# CITY OF PORTLAND, MAINE

**Project Name:** Munjoy Heights  
Six new buildings comprising 29 residential townhouses; one existing house on reconfigured lot

**Project ID:** 2013-228

On December 17<sup>th</sup>, 2013 the Portland Planning Board considered and approved a Level III Final Site Plan and Subdivision proposal to construct a 30 "lot" residential subdivision made up of 29 new units in six 3-4 story townhouse-style buildings and one existing residential building on a reconfigured lot.

FILE: 1047.CML DATE: 2/17/14 SHEET: 1047 SCALE: 1"=20' DESIGN BY: WMS DRAWING BY: WMS CHECKED BY: WMS		DRAWING NAME: <b>WALNUT STREET CROSSWALK PLAN</b>	PROJECT NAME: <b>MUNJOY HEIGHTS</b>
		CLIENT: <b>REDFERN MUNJOY, LLC.</b> P.O. BOX 8816, PORTLAND, MAINE 04104	
<b>SK-1</b> DRAWING NO.		REVISIONS

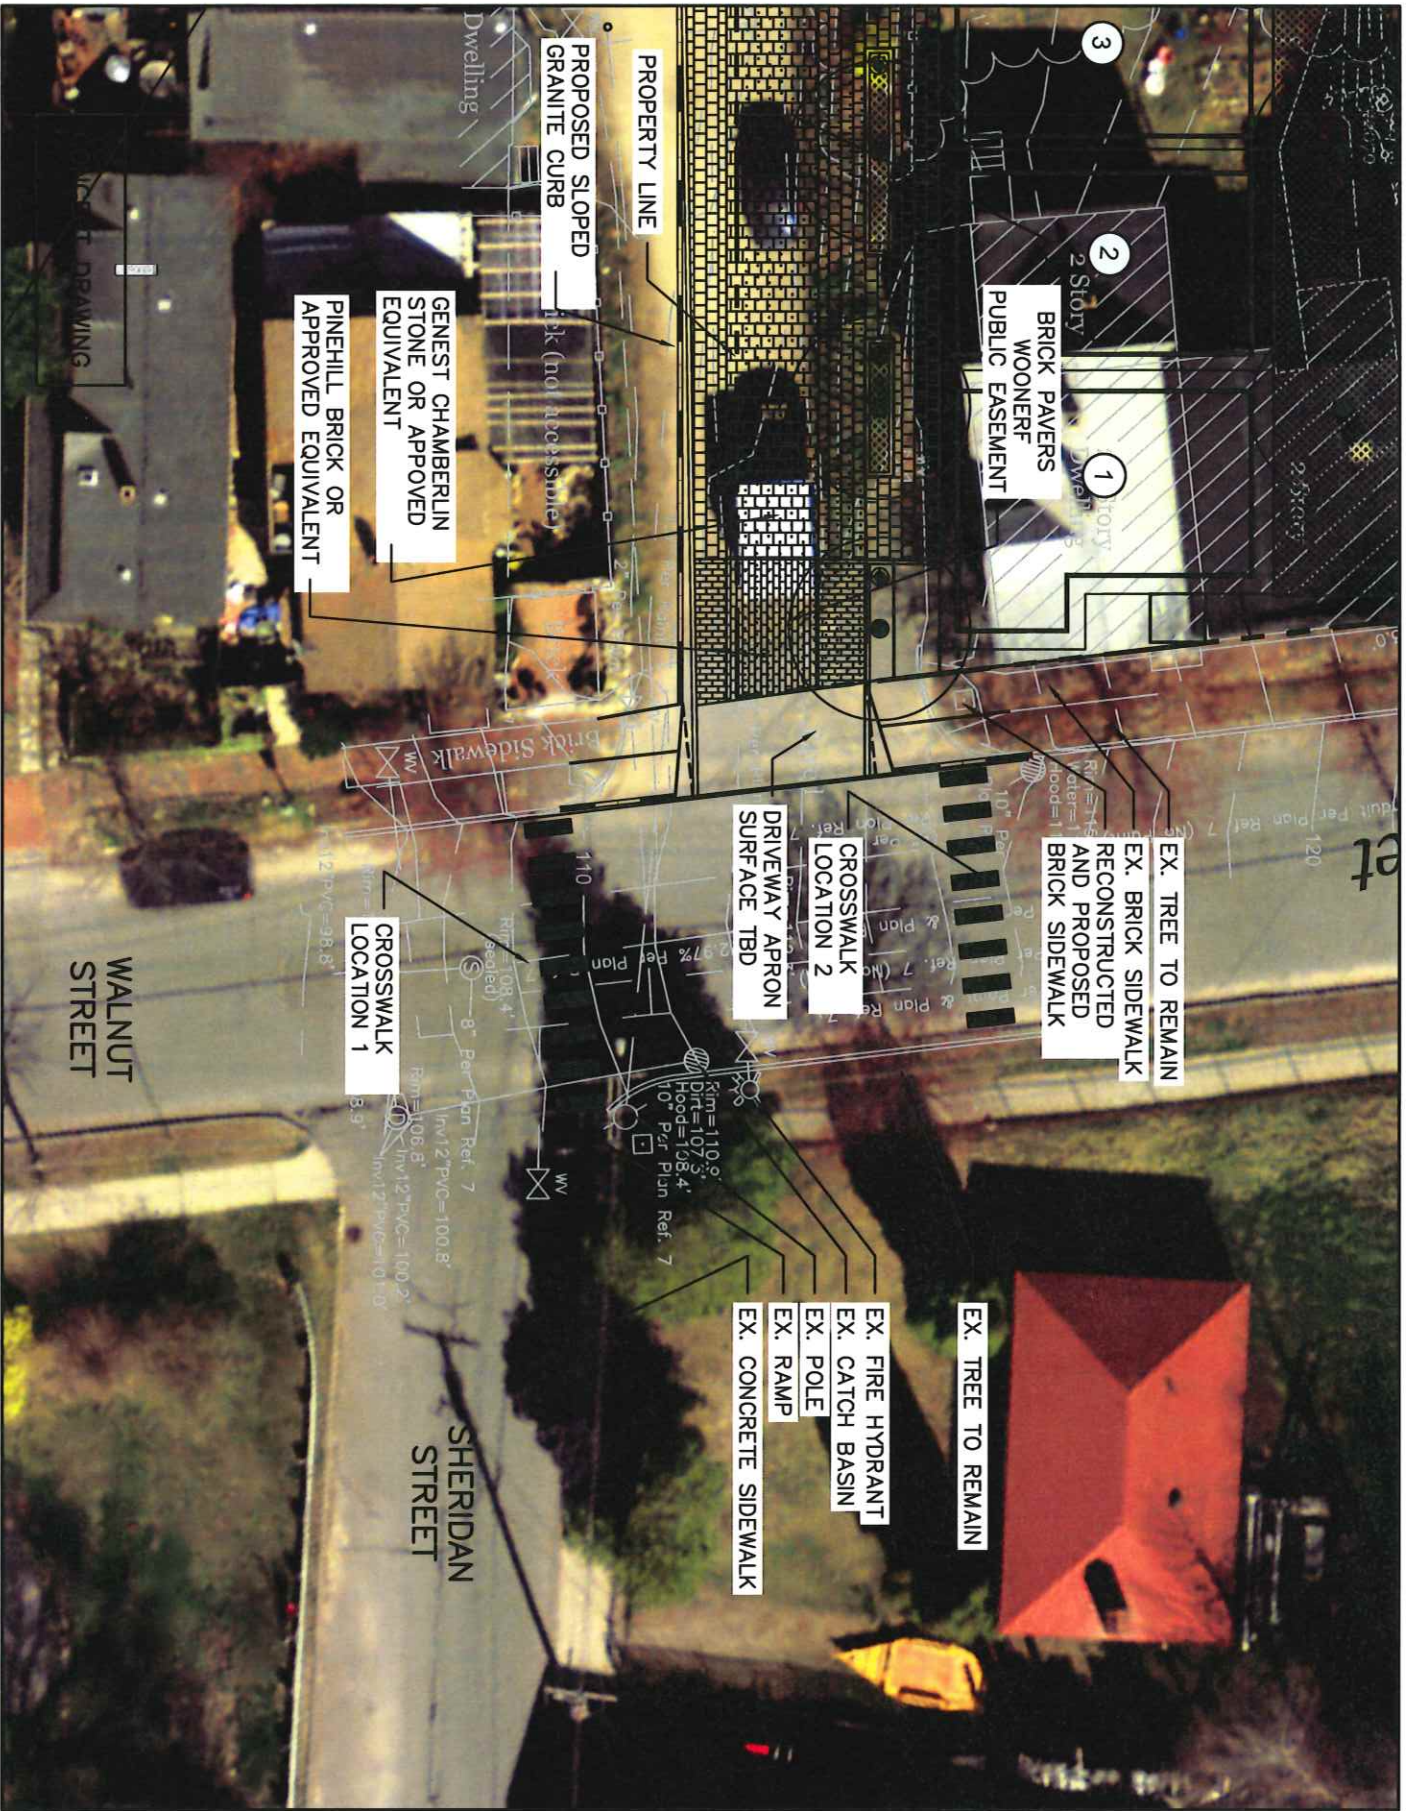
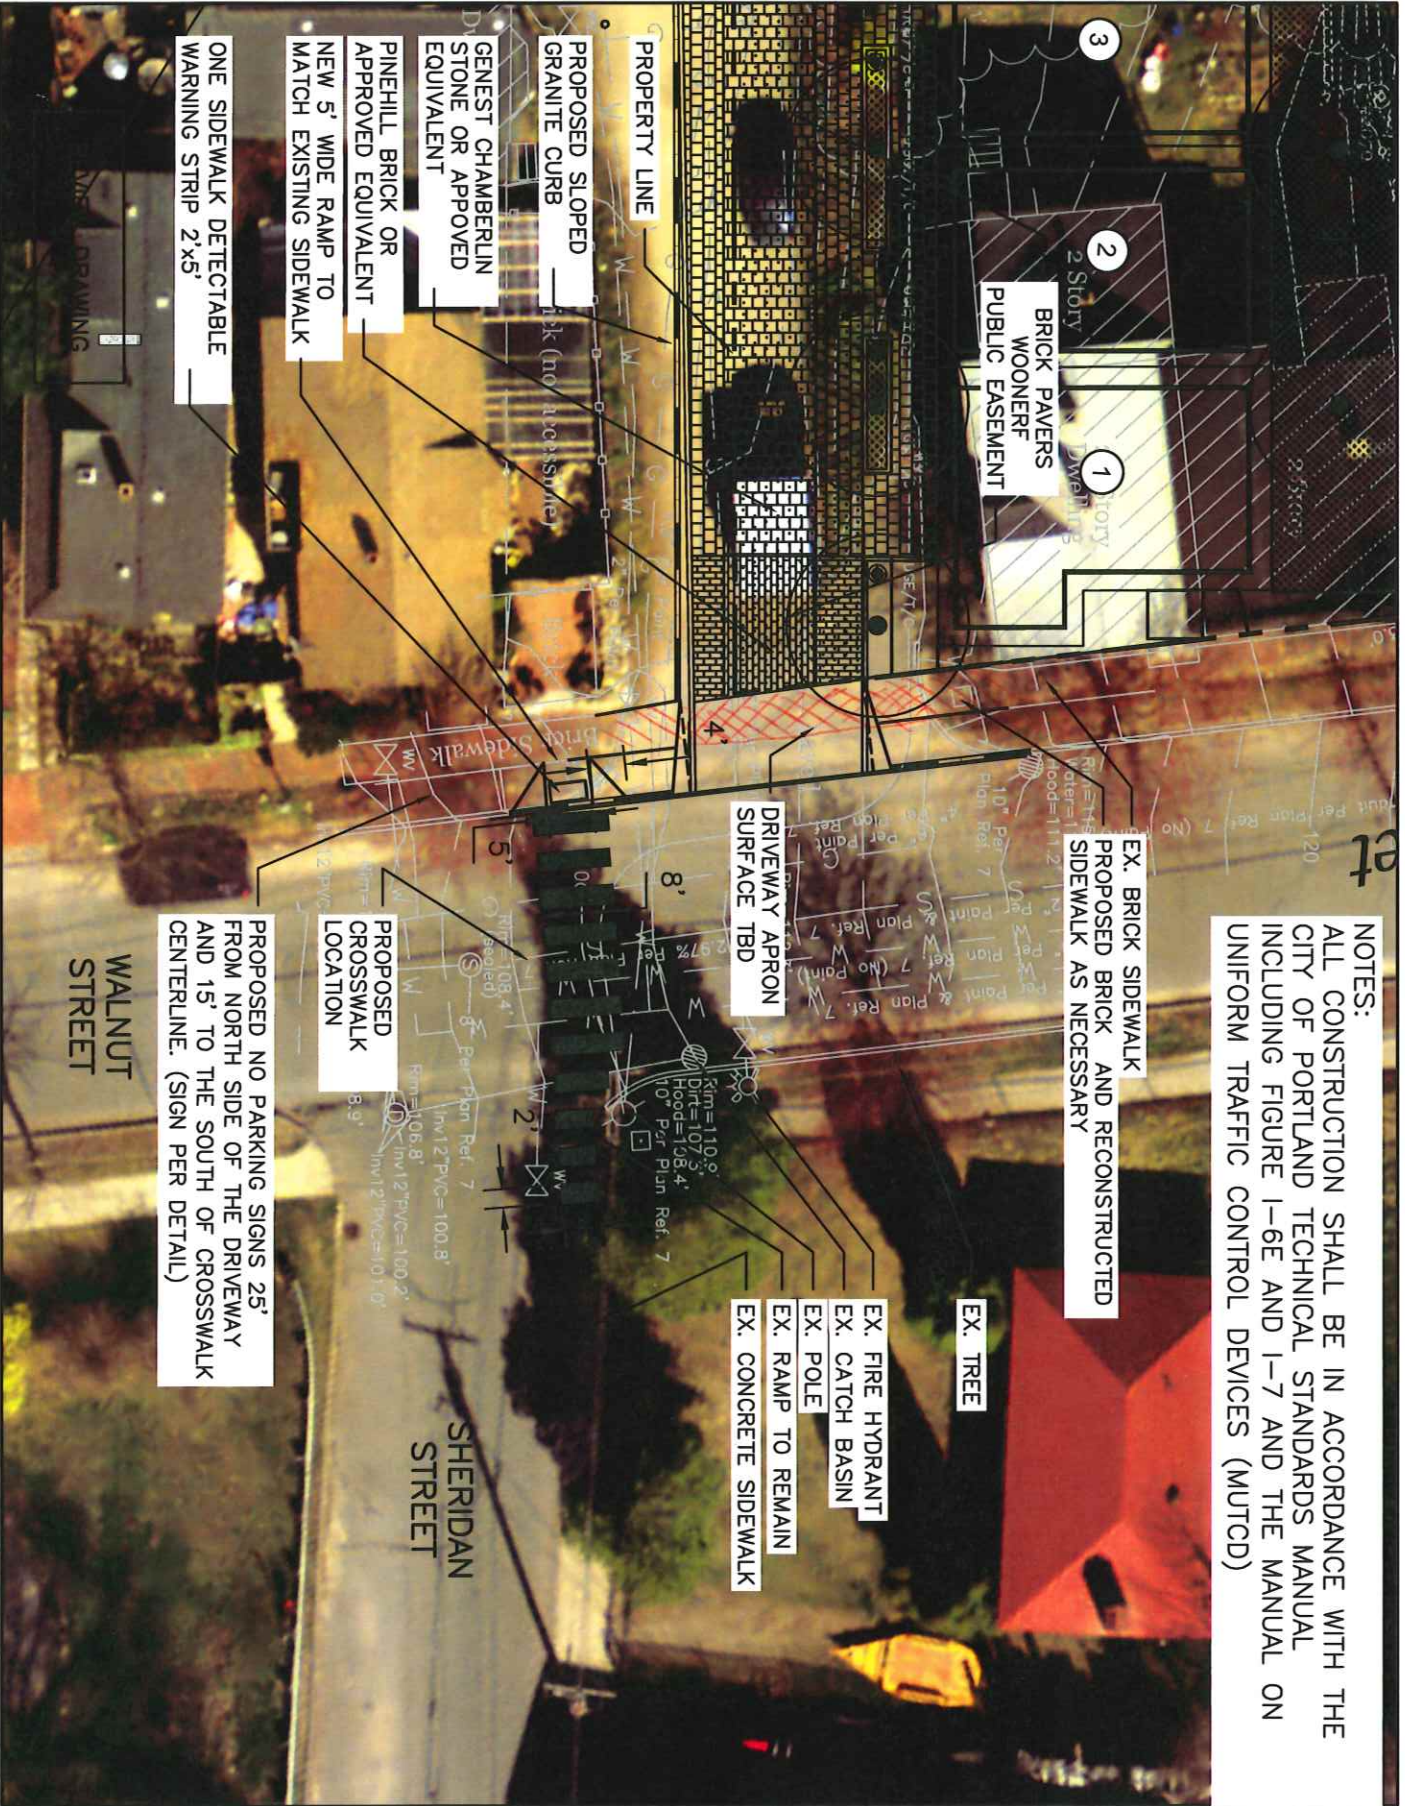
1. Per Jean Fraser's email dated 5/7/14 should I change the note "Driveway Apron Surface TBD" to a brick driveway apron (per City Standard detail I-11).

DRIVEWAY APRON SURFACE TBD

The City Council is recommended to approve the material substitution (brick to be substituted for asphalt in apron area) as shown on the attached plan, and the associated attached maintenance and replacement easement.
